1188 BIDWELL STREET (COMPLETE APPLICATION)
DE419087 - ZONE C5-A

DEVELOPMENT PERMIT STAFF COMMITTEE MEMBERS

DEVELOPMENT PERMIT STAFF COMMITTEE RECOMMENDATION: APPROVE

Base Surface Plan/
Building Height

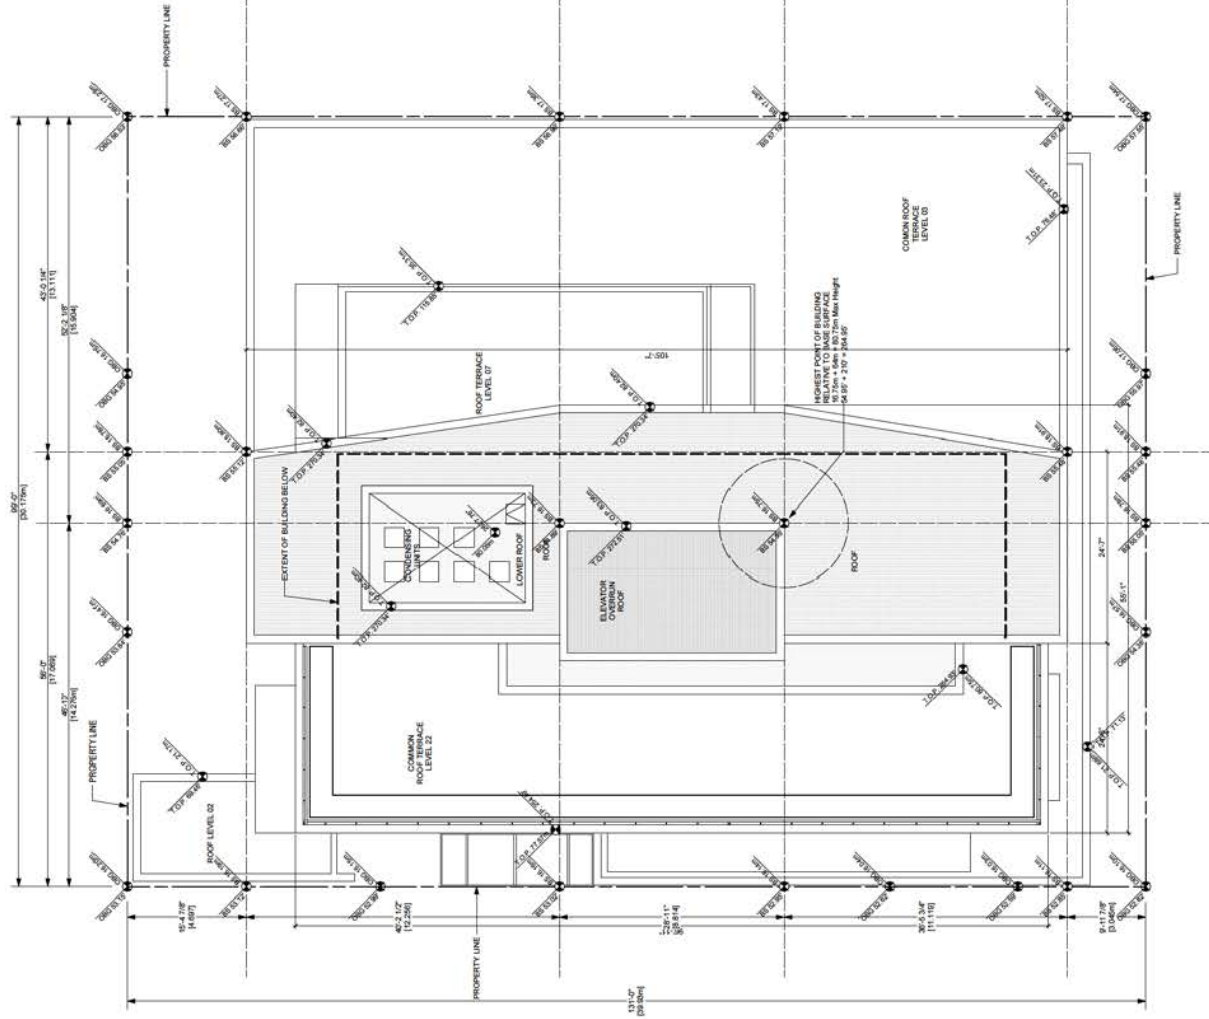
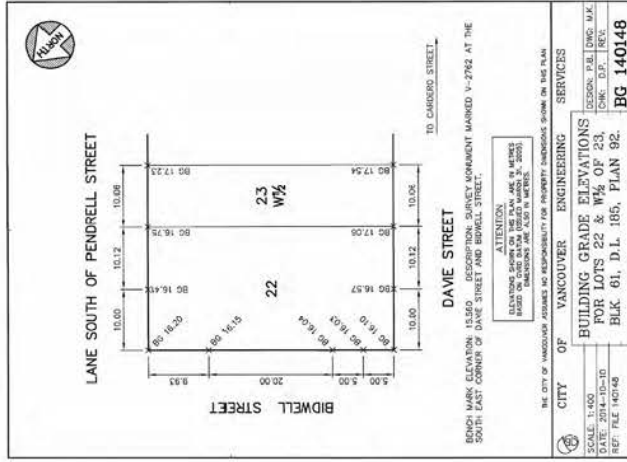
- 1.1 compliance with Section 4.3.2 - Height regulation in the C-5A District Schedule;

Note to Applicant: A reduction of 6.1 feet is required to meet the maximum height permitted in this area.

2 Planting Plan Level 3

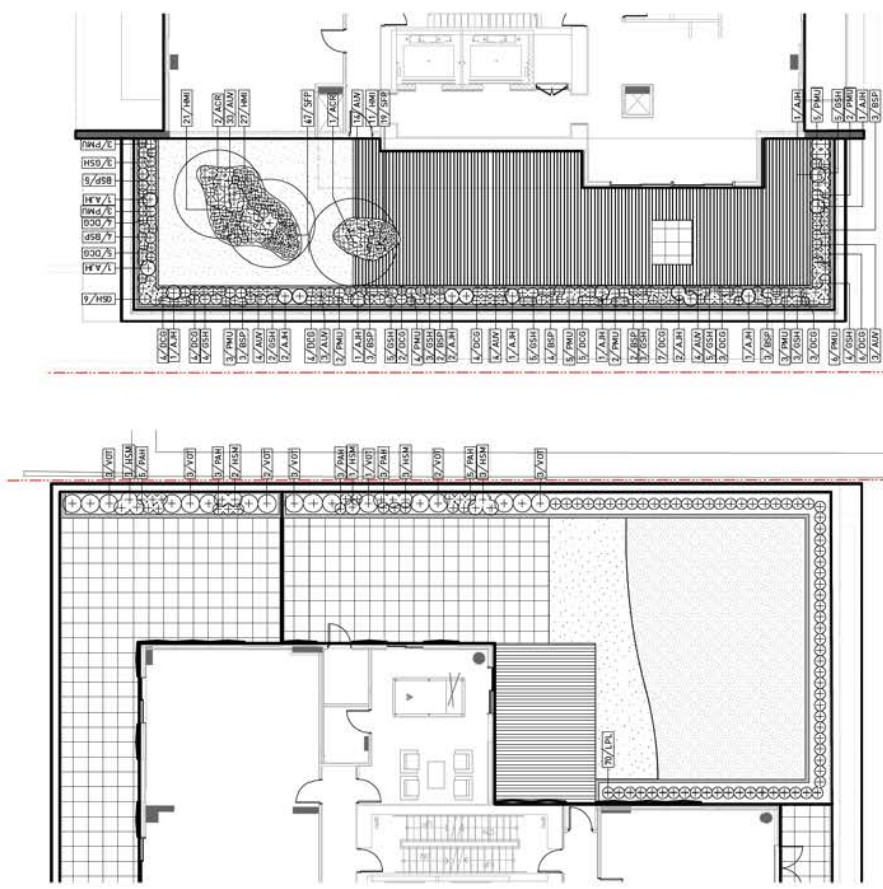
A.1.10 provision of additional planters and shade trees, as follows;

- at level 3, provide enlarged planters of a sufficient size (4 foot square planter width) to accommodate shade trees at the four corners of the child play area;
- at level 3, provide an enlarged planter of a sufficient size (4 foot square planter width) to accommodate one tree at the north east corner of the private patio;
- at level 7, provide an enlarged planter of a sufficient size (4 foot square planter width) to accommodate one tree at the north east corner of the private patio.
